**FOLLOW-UP TO
RESPONSE TO 10-25-21-RAI EYE Lighting email out**

December 6, 2021

APPENDIX F: Method Of Labeling Or Marking Kr85

Figure 1:Kr85 in Monogram

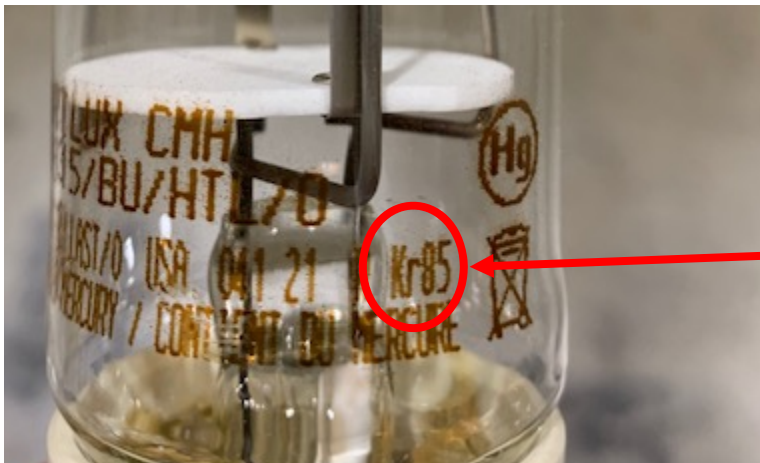
I have Updated Appendix F for the Kr-85 labeling. Only Appendix F is part of this file.

Kr85 in Monogram
